Memorandum to the City of Markham Committee of Adjustment

File: B/36/17, A/137/17
Address: 21 Lanor Court , Markham
Applicant: Samithamby and Shivamthin Harichandran
Agent: QX4 Investments Ltd. - Consulting Services
Hearing Date: Wednesday July 25, 2018

Memorandum to the City of Markham Committee of Adjustment

Files: B/36/17, A/135/17 and A/136/17
Address: 21 Lanor Court, Markham
Applicant: Samithamby and Shivanthini Harichandran
Agent: QX4 Investments Ltd. - Consulting Services
Hearing Date: June 13, 2018

Figure 2 - Site Plan

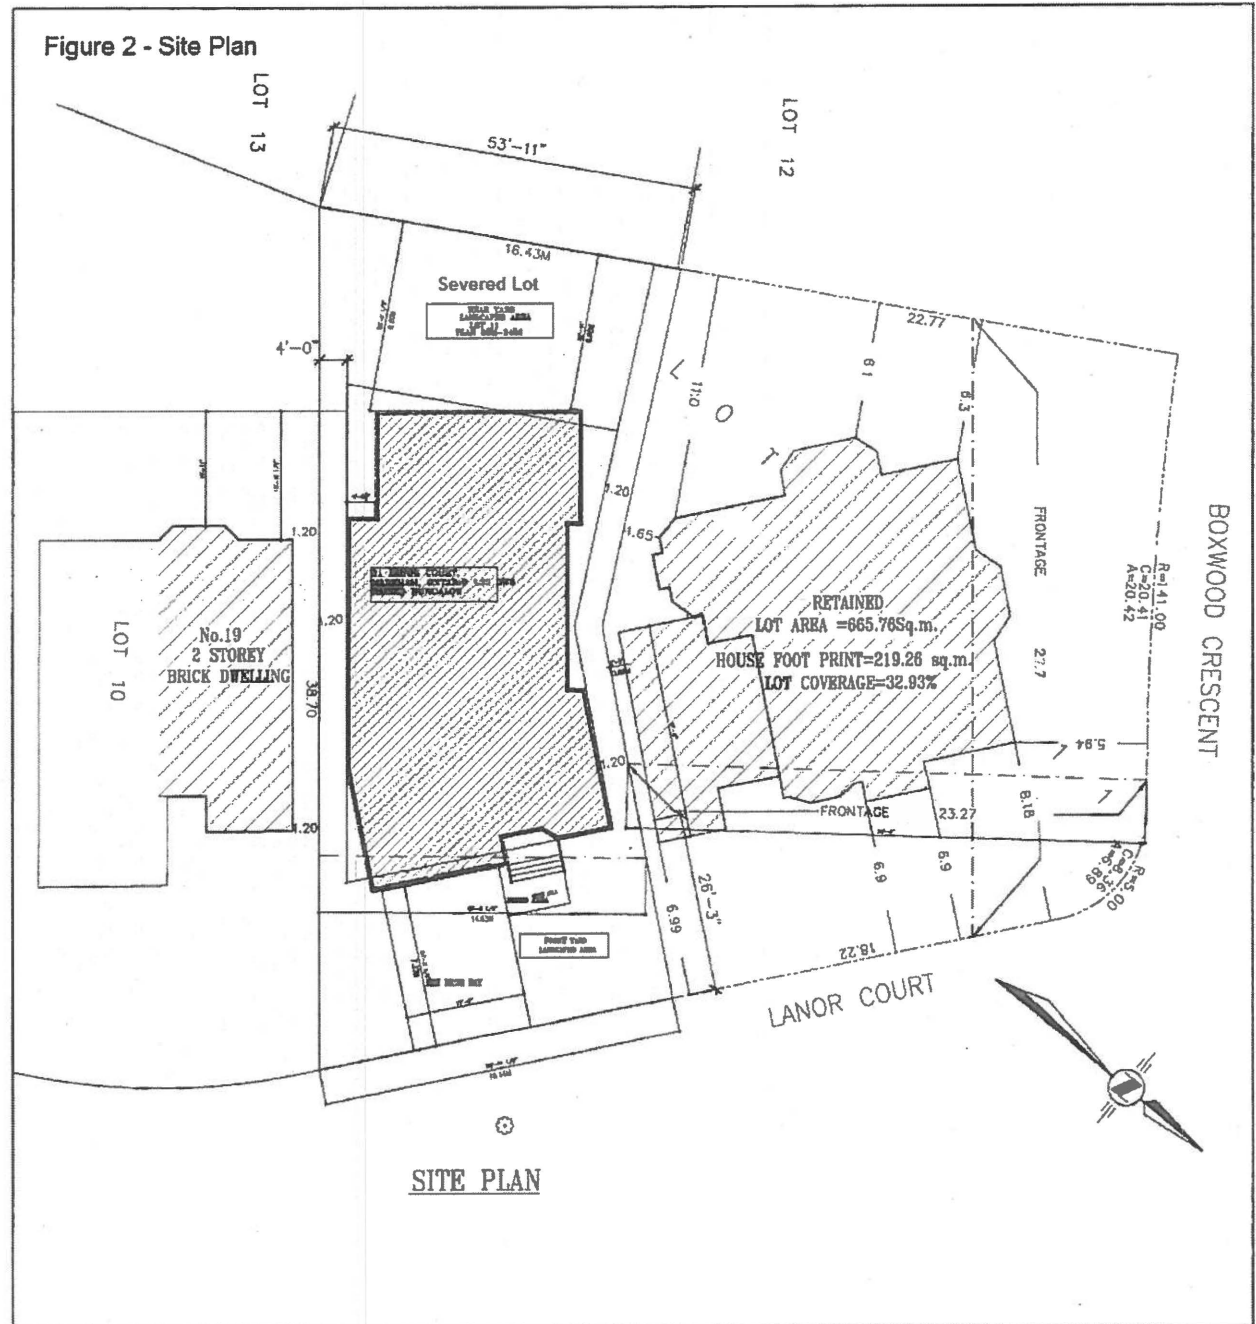
To ensure that the variances relate to the dwelling as proposed, particularly as a predominantly one storey building, staff recommend a condition that any approved variances for the 'severed' lot reflect the plans submitted with these applications and shown on Figure 2. Similarly, staff recommend a condition that approval of the requested side yard setback reduction apply to the south side yard only, as reflected on the plans submitted with this application (Figure 2).

The side yard setback variances relate to the separation between the south wall of the existing dwelling and proposed lot line abutting the 'severed' lot. Staff requested the 'severed' lot be widened, which was accommodated by the applicant. This resulted in the need for reduced side yards on the 'retained' lot to accommodate the living space within

- 1) The variances apply only to the existing development as long as it remains;
- 2) That the variances apply only to the subject development, in substantial conformity with the plan(s) attached as 'Figure 1' to this Staff Report and dated July 1, 2017 (stamped received by the Committee of Adjustment May 18, 2018).
- 3) That the existing circular driveway be replaced with a driveway that has only one access to Lanor Court to the two-car garage, to the satisfaction of the Director of Planning and Urban Design.

- 1) The variances apply only to the proposed development as long as it remains;
- 2) That the variances apply only to the subject development, in substantial conformity with the plan(s) attached as 'Figure 1' to this Staff Report and dated July 1, 2017 (stamped received by the Committee of Adjustment May 18, 2018).
- 3) That the requested variance for a side yard reduction only applies to the southerly side yard and only to a portion of the second storey of the proposed dwelling as shown in the plans referenced in condition 2) above.

Figure 3 - Second Floor Plan - Proposed Dwelling on 'Severed' Lot

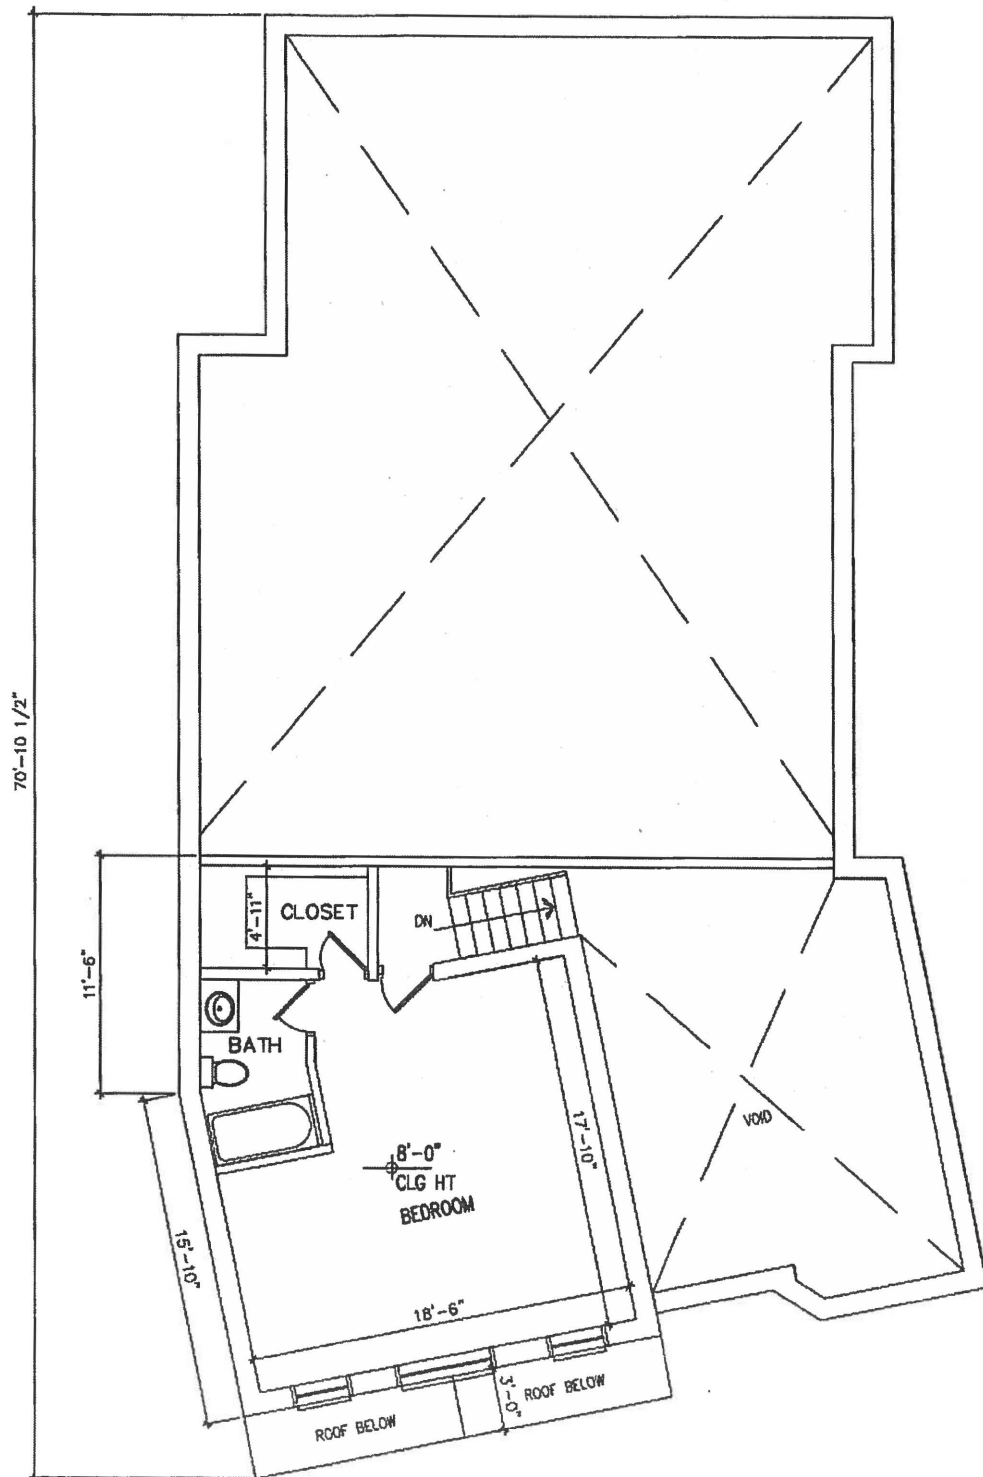
By-law 90-81, as amended permits the first storey of a dwelling to have a minimum side yard setback of 1.2 m, but requires storeys above the first storey to have a minimum side yard setback of 1.8 m. As noted, the majority of the dwelling is one storey in height, except for a 2nd storey bedroom at the southeast portion of the building. The requested side yard variance applies to this section of the proposed house only. Staff do not have concern with this requested variance.
